WETHERILL PARK

RESOURCE RECOVERY AND RECYCLING FACILITY
Response to Submissions

SSD 7401

Prepared for **Bettergrow Pty Ltd**

PROJECT	PROPOSED GREENSPOT RESOURCE RECOVERY AND RECYCLING FACILITY 24 DAVIS ROAD WETHERILL PARK NSW 2164	PROJECT NO.	1521
CLIENT	BETTERGROW	SCALE	1: 100
TITLE	FOOD DEPACKAGING AND PROCESS BUILDING FLOOR PLAN	JOB NO.	0604-16
		SHEET NO.	C01
		ISSUE	C

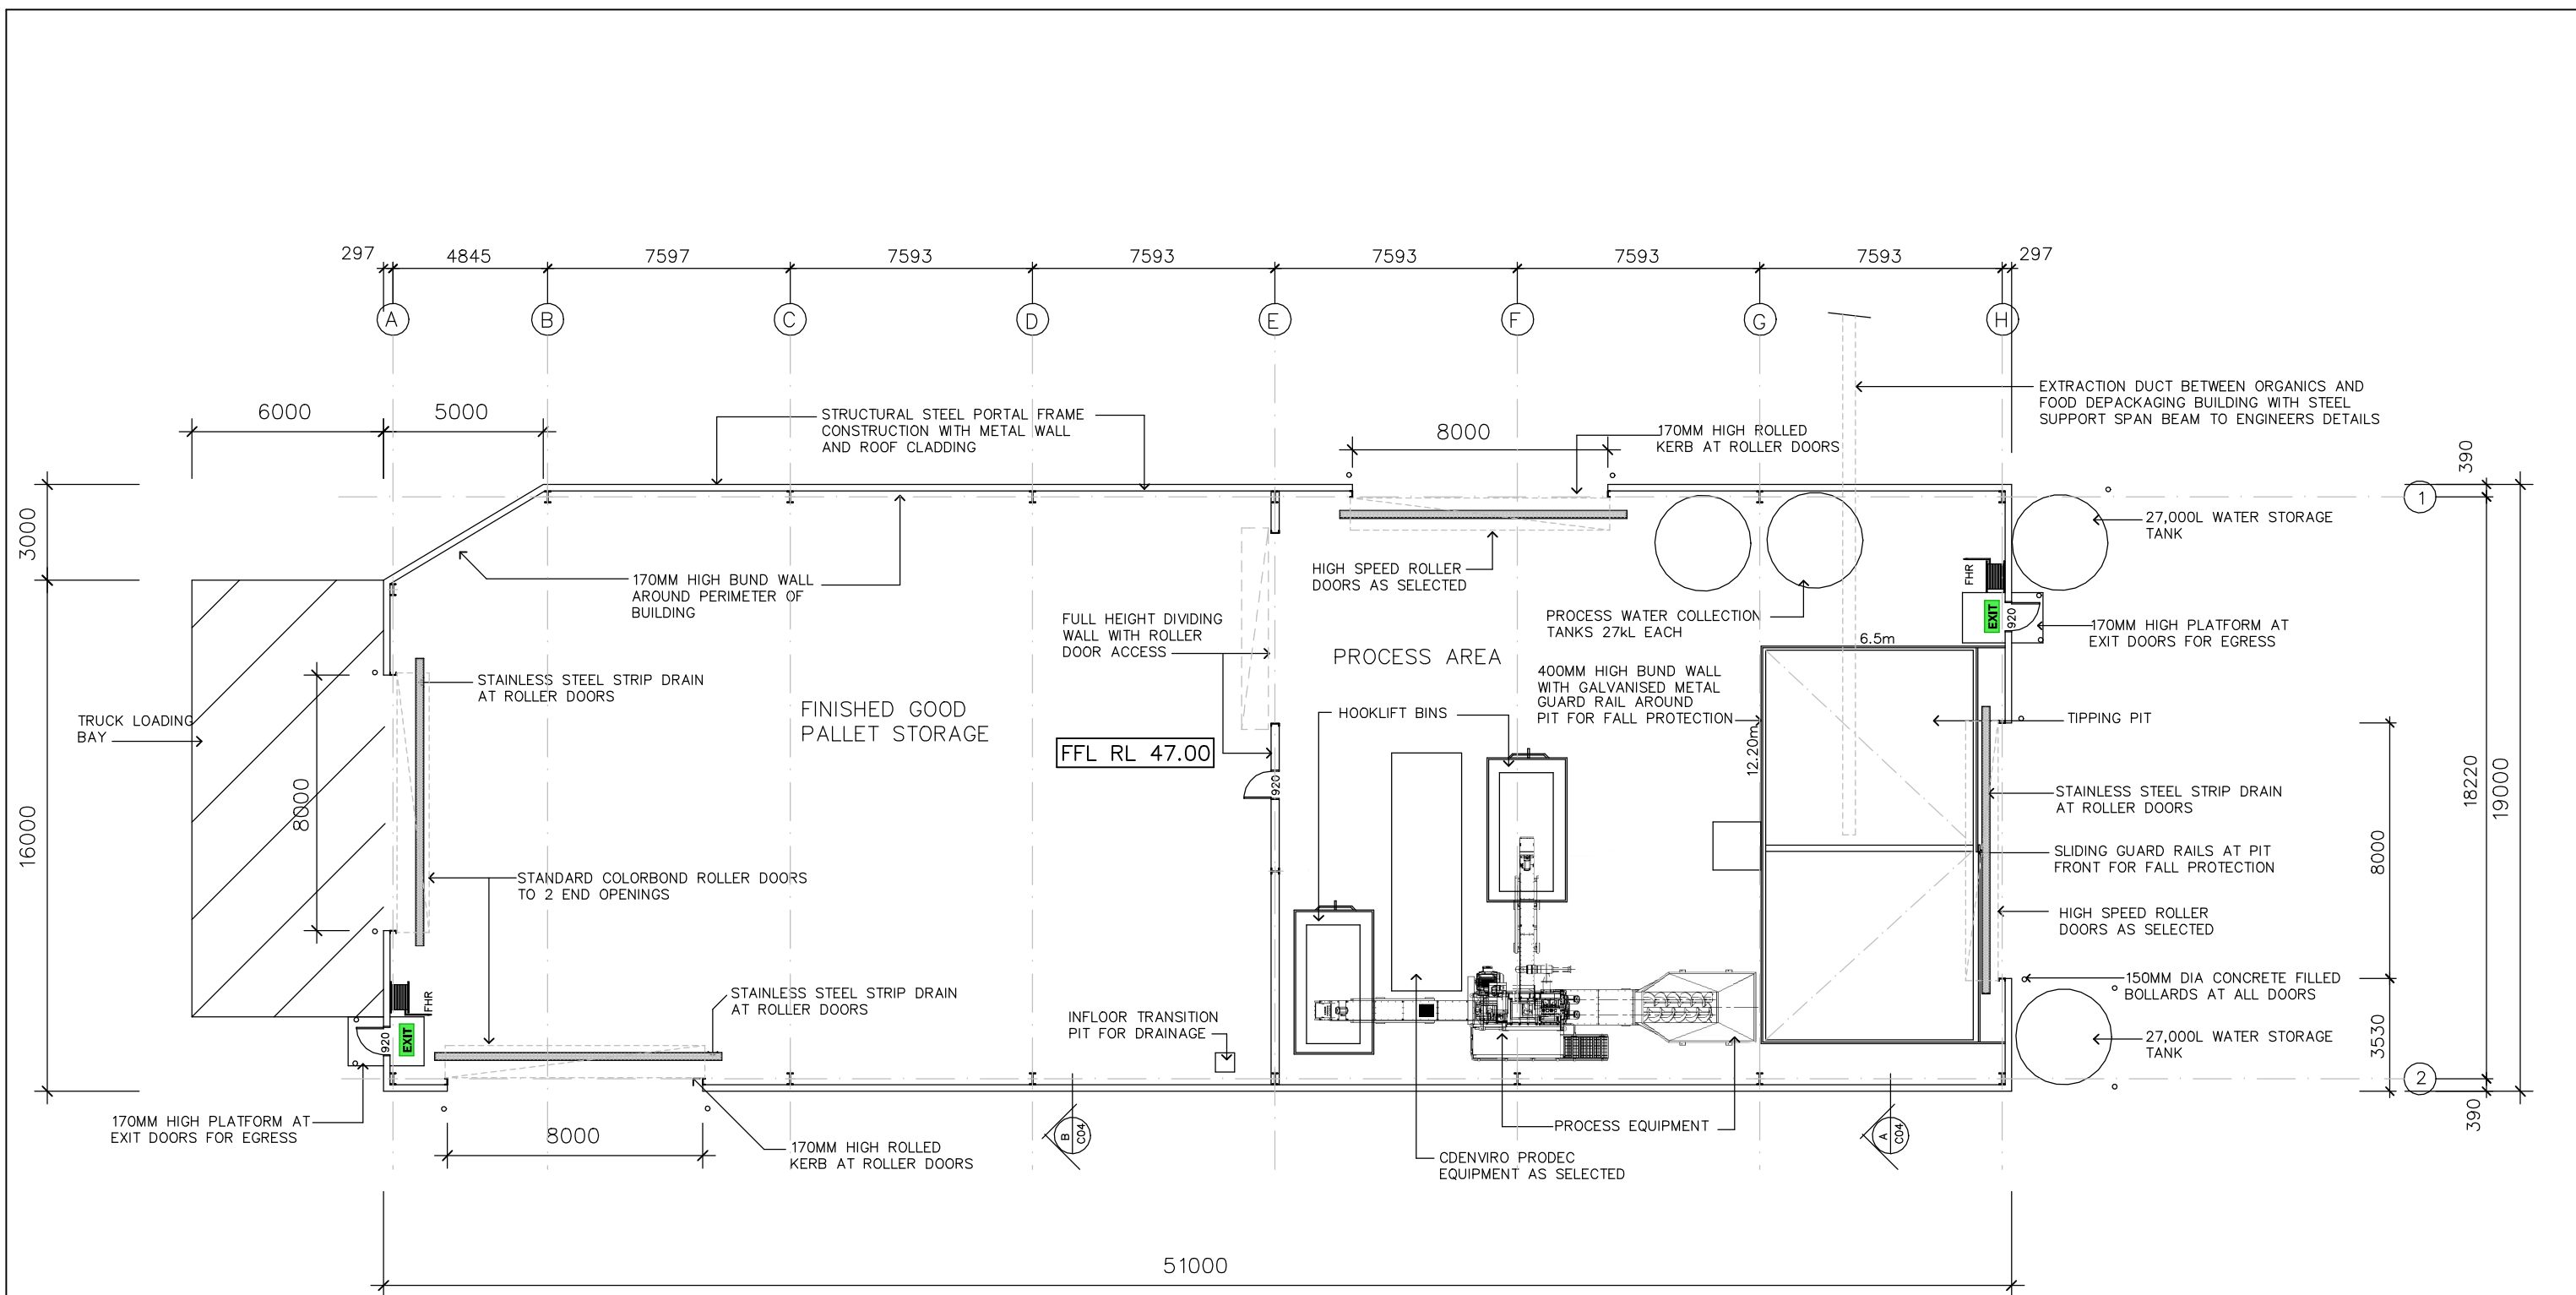
3. Please detail how many tonnes can be stored in the food de-packaging tip pit

Whilst architectural drawings supplied with the EIS show a tip pit depth up to 3 metres, the depth of the pit has been reduced to 2.2 metres internally (2.55m externally) to ensure that the base of the pit does not exceed RL44.5m which is the minimum base depth to ensure the groundwater table is not intercepted. This specification is as per the recommendations of the Groundwater Impact Assessment prepared for the EIS. Refer to **Appendix 2, Sheet C01** of this report for a revised plan of the Food De-packaging building and the revised tip pit depth.

TITLE: **FIGURE 42: EROSION AND SEDIMENT CONTROL PLAN** | LOCATION: **DAVIS RD WETHERILL PARK** | DATUM: **GDA94** | DATE: **9/08/2017** | AUTOCAD REF: **J:\085\127\127695 Wetherill Park\10 - Drafting\Worthrop C A3 (JH-NW)**
 PROJECTION: **MGA ZONE 56** | PURPOSE: **PLANNING**

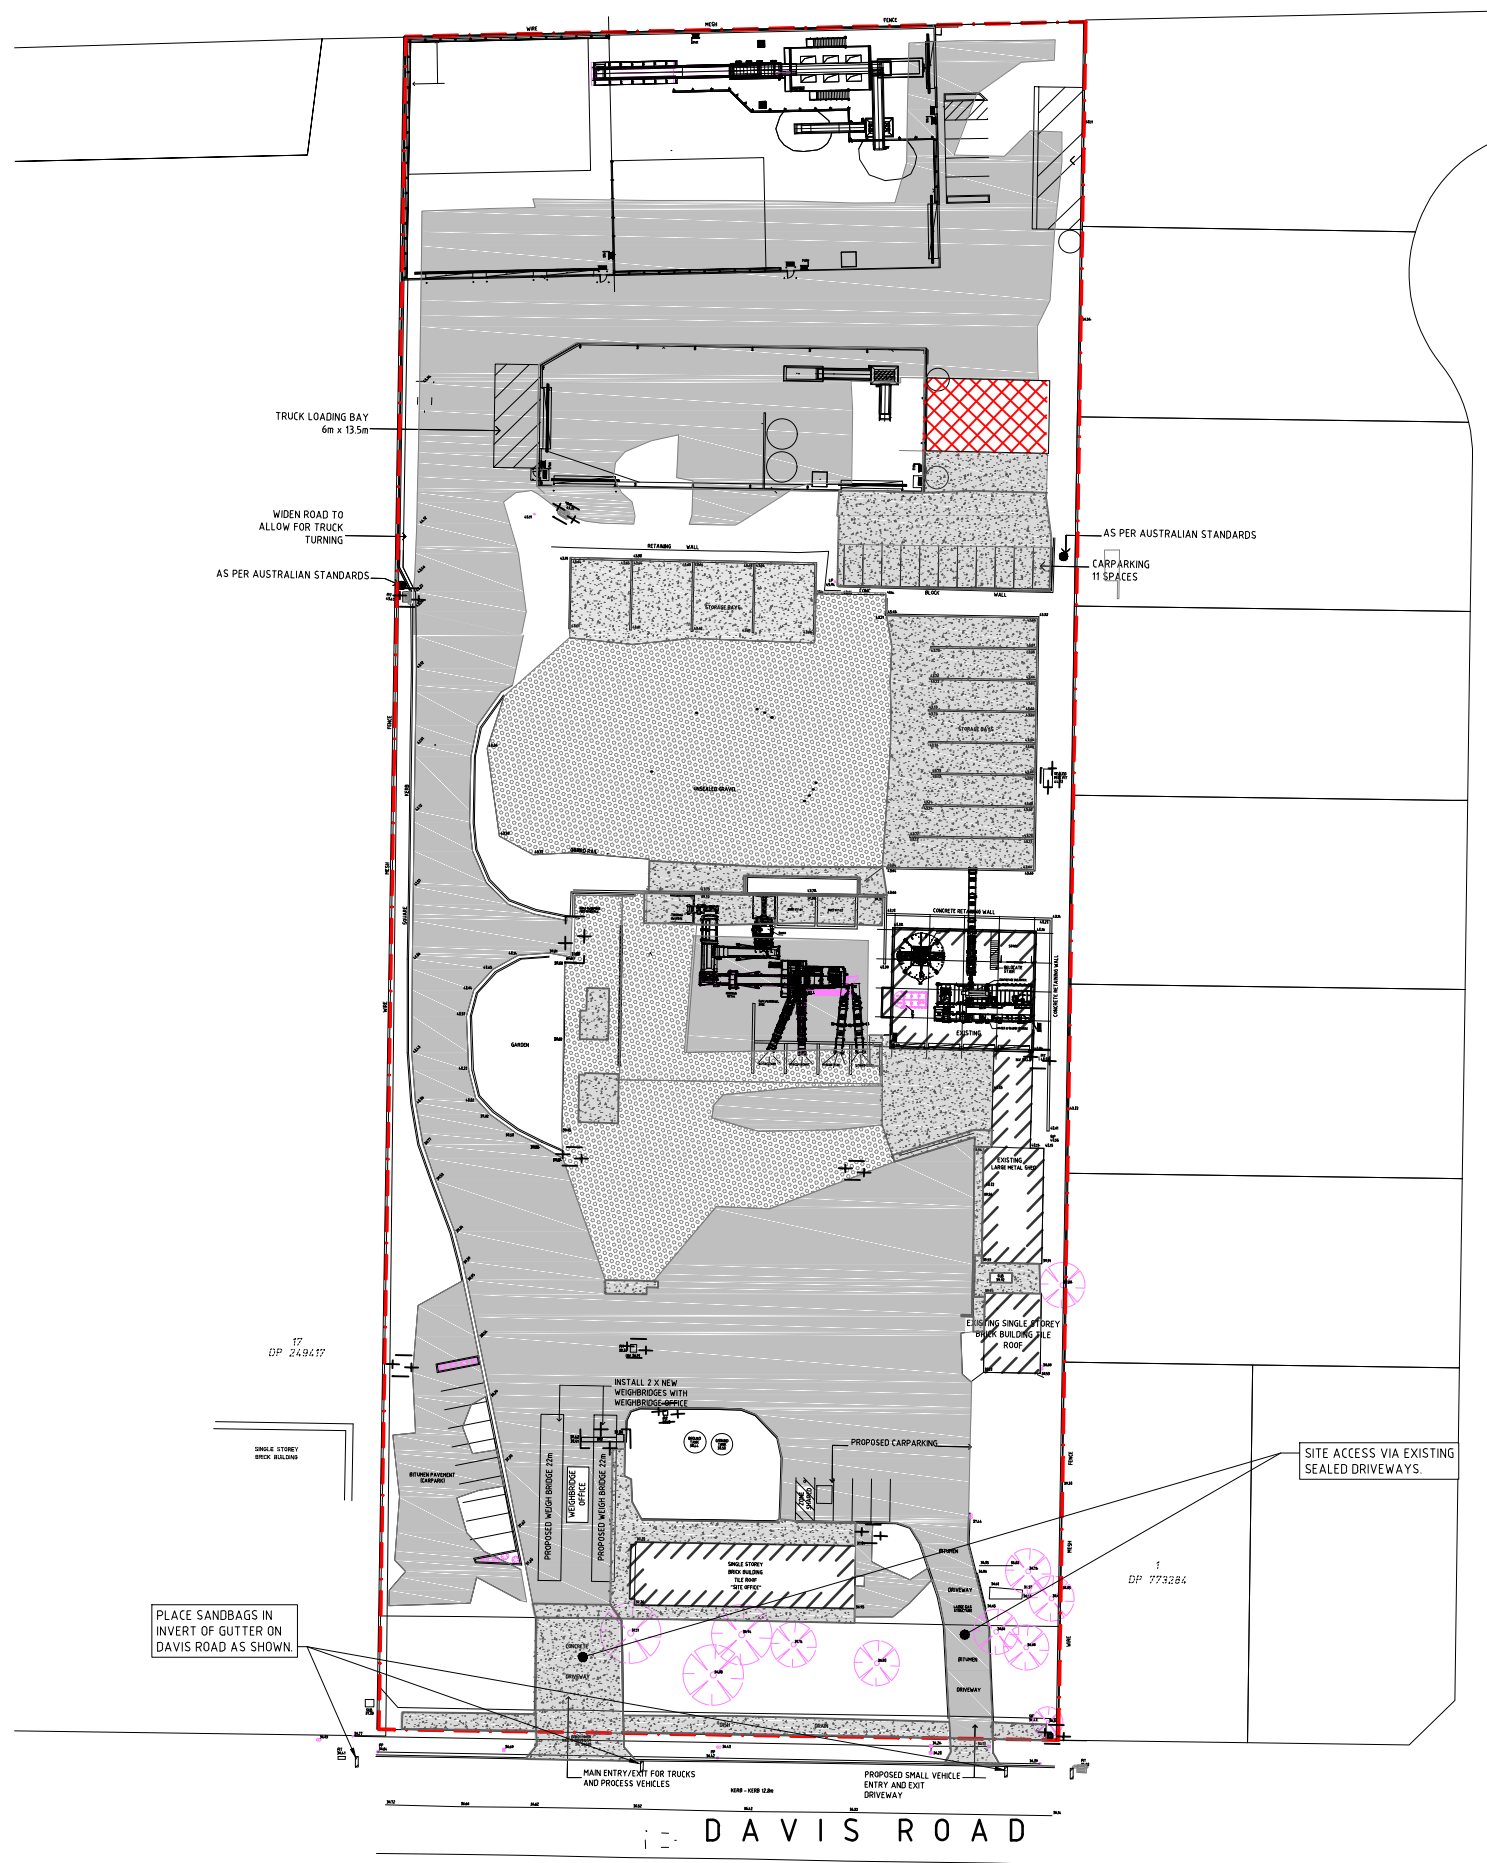
5. Figure 42 of the EIS shows a stockpile located on the gravel area in the landscaping area. Please detail the height of stockpiles and why stockpiles are not located within designated bays

The placement of this stockpile on Figure 42 is to depict a temporary indicative stockpile that may be required during the construction of the facility. This is a standard addition to an erosion and sediment control plan as required by the 'Blue Book'. This stockpile is not to represent materials being stored during operations and nor will stockpiling occur outside of designated bays during operations.

A revised Figure 42 has been prepared whereby the temporary stockpile has been removed. Refer to **Appendix 2, Figure 42** of this report for the revised plan.

TITLE: FIGURE 11: PROPOSED SITE LAYOUT
MID & LOWER LEVELS

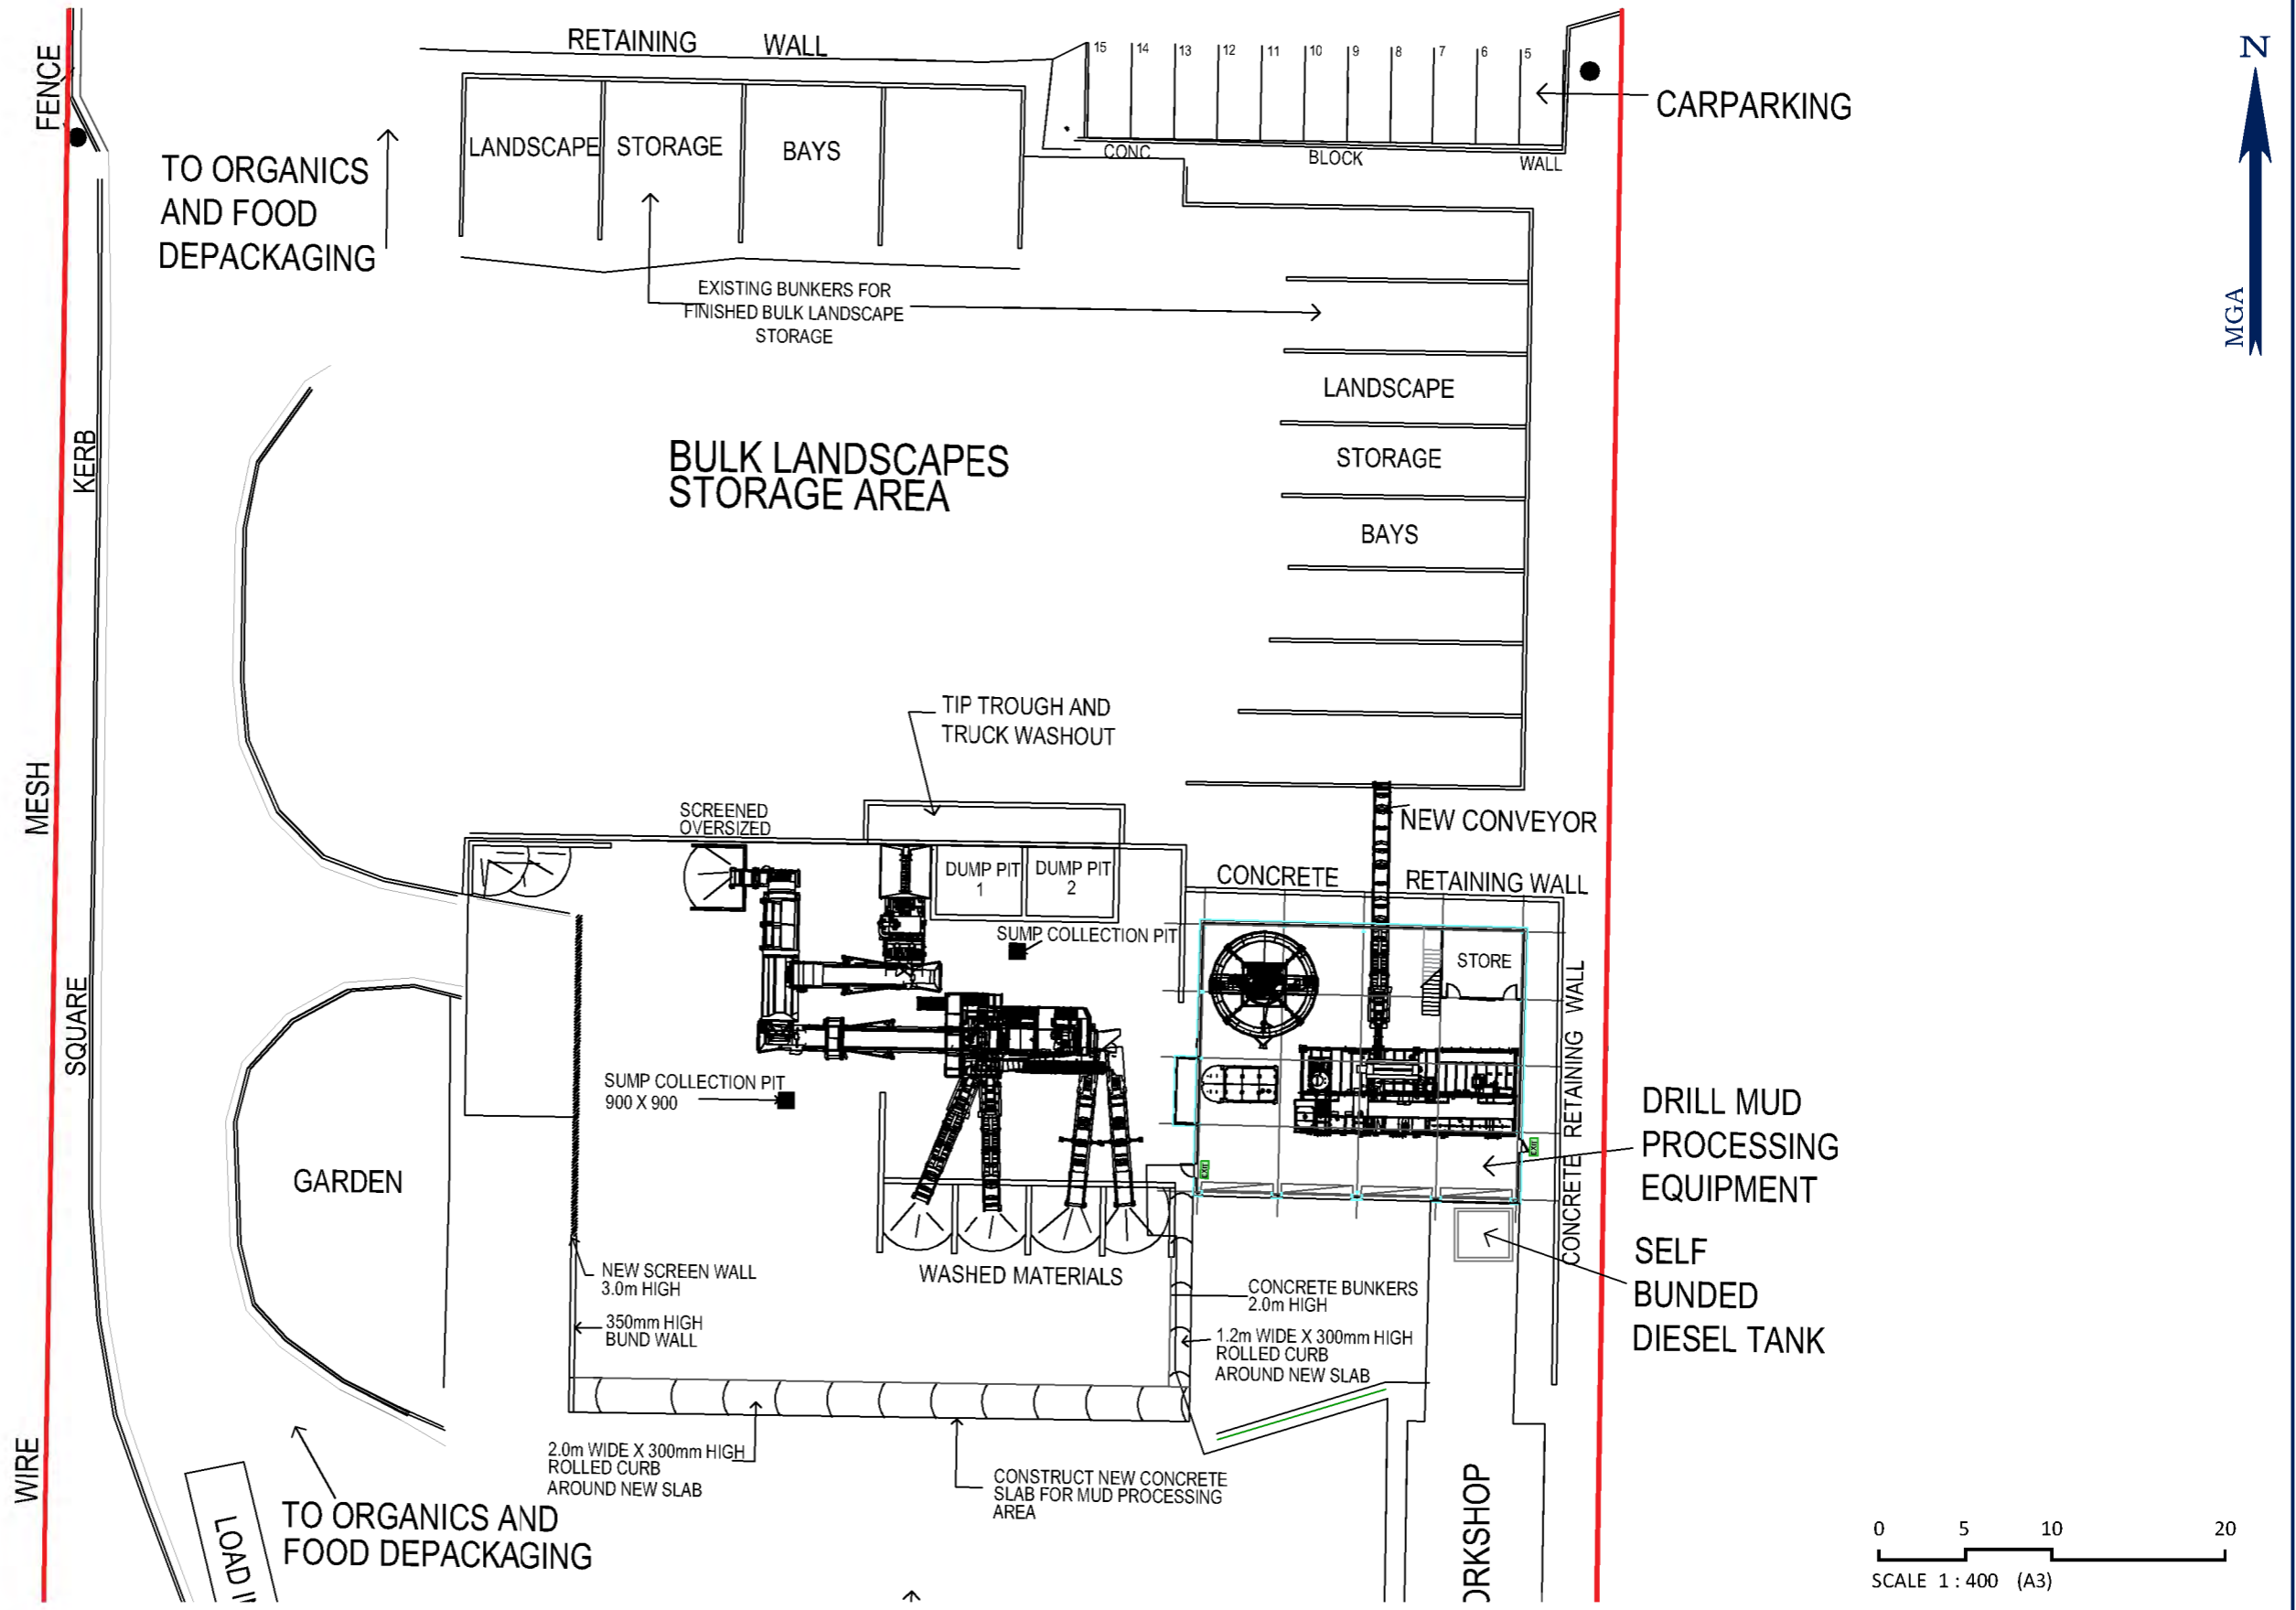
8. Please detail on a plan where the 5,000 litre diesel tank will be stored (see Page 191 of the EIS)

The site storage shed (approximately 15.4 m x 8.0 m) has a single large roller door and standard door for entry. This shed will be used to house spare parts, replacement equipment, general maintenance items, and cleaning products. In addition, the storage shed will also contain oils and lubricants required for the maintenance of site plant and machinery, and a 5,000 litre self bunded diesel tank. These items will be stored and handled in accordance with Australian Standard (AS) 1940-2004 *The Storage and Handling of Flammable and Combustible Liquids* and Work Health and Safety regulations.

Refer to **Appendix 2, Figure 11** of this report for a revised plan showing the location of the 5,000 litre diesel pod.
